SUBJECT: ISSUANCE OF AMENDMENTS - VOGTLE ELECTRIC GENERATING PLANT,
UNITS 1 AND 2 (TAC NOS. M91240 AND M91241)

SUBJECT: ISSUANCE OF AMENDMENTS - VOGTLE ELECTRIC GENERATING PLANT,
UNITS 1 AND 2 (TAC NOS. M91240 AND M91241)

SAFETY EVALUATION BY THE OFFICE OF NUCLEAR REACTOR REGULATION

VOGTLE ELECTRIC GENERATING PLANT, UNITS 1 AND 2

TYPICAL PENETRATION ARRANGEMENT

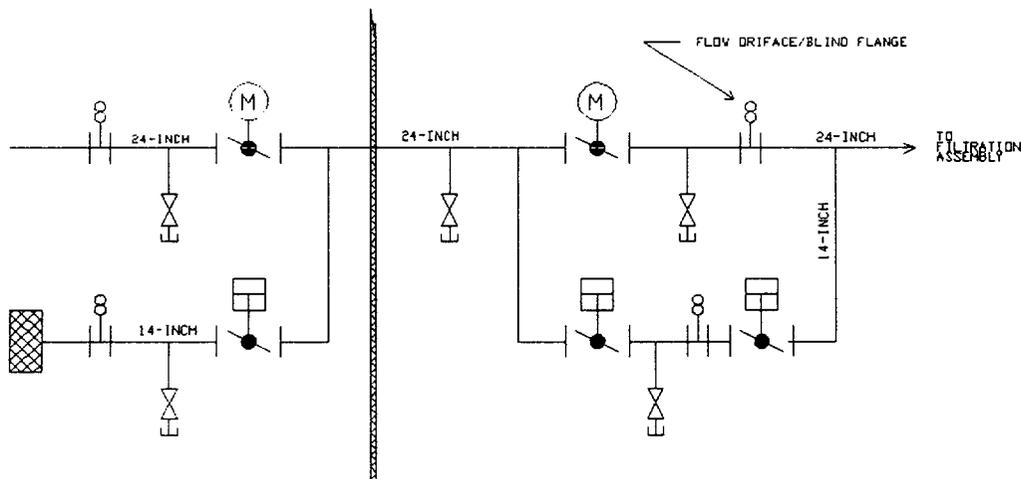
Primary containments are provided with vent/purge systems to enable the containment to be vented and purged as necessary for control of containment pressure and airborne radiation levels. Large lines (i.e., 24-inch diameter) are used during outages. These lines are sealed closed during power operation. Smaller (i.e., 14-inch diameter) "mini-purge" lines are used on a non-routine basis during power operation. The containment penetration arrangement is depicted in the figure below. The purpose and use of these lines is discussed in greater detail in Branch Technical Position CSB 6-4 in Standard Review Plan Section 6.2.

The 24-inch and 14-inch diameter containment isolation valves installed in the VEGP vent/purge system are butterfly-type valves with seals made of a resilient material. Because valves of this design have a history of high leakage rates and rapid deterioration, and because the associated leakage path provides significant potential for release of fission products in the event of an accident, the staff imposed accelerated testing requirements (i.e., beyond the minimum Appendix J leak rate requirements) on such valves. The staff position related to surveillance testing of large containment vent/purge valves with resilient seal material is identified in the improved Standard Technical Specifications (STS). The improved STS specify a leakage testing frequency of 184 days and within 92 days of opening the valve. These requirements are intended to apply to all sizes of containment purge valves with resilient seals except for valves installed in lines that are isolated by blind flanges during power operation. In order to minimize personnel radiation exposure, the staff permits the additional leakage tests that are conducted at power to be performed using methods that do not require containment entry. The at-power tests may involve a test method that is not identical to the 10 CFR Part 50, Appendix J test procedure. (The VEGP TS do not reflect this position, but instead indicate that all purge valve leakage tests will be "Type C" [i.e., use the 10 CFR Part 50, Appendix J methodology and criteria for leakage testing of containment isolation valves]).

The 24-inch and 14-inch vent/purge valves at the VEGP are currently required by TS to be Appendix J/Type C leak-tested at 3-month intervals. Because the Type C test method is specified, the tests involve containment entry and the erection of scaffolding to permit installation of blank flanges to enable the inboard valves to be tested with the pressure applied in the accident direction.

The licensee proposes to reduce the Type C test frequency for containment purge valves to 24 months consistent with 10 CFR Part 50, Appendix J test interval requirements for Type C leakage testing. The application is based on the results of a total of over 400 Type C tests conducted on the four valves in each of the four penetrations over the period of 1987-1994. No valve exceeded its leakage rate test acceptance criterion of 26,320 standard cubic centimeters per minute on either an initial test or retest. (On some of the tests, above-average leakage rates were observed and retests conducted. In these cases, the leakage was found to be due to reasons other than resilient seat leakage).

The leakage testing interval for the VEGP vent/purge valves may be extended to 24 months, the maximum interval permitted by 10 CFR 50, Appendix J.
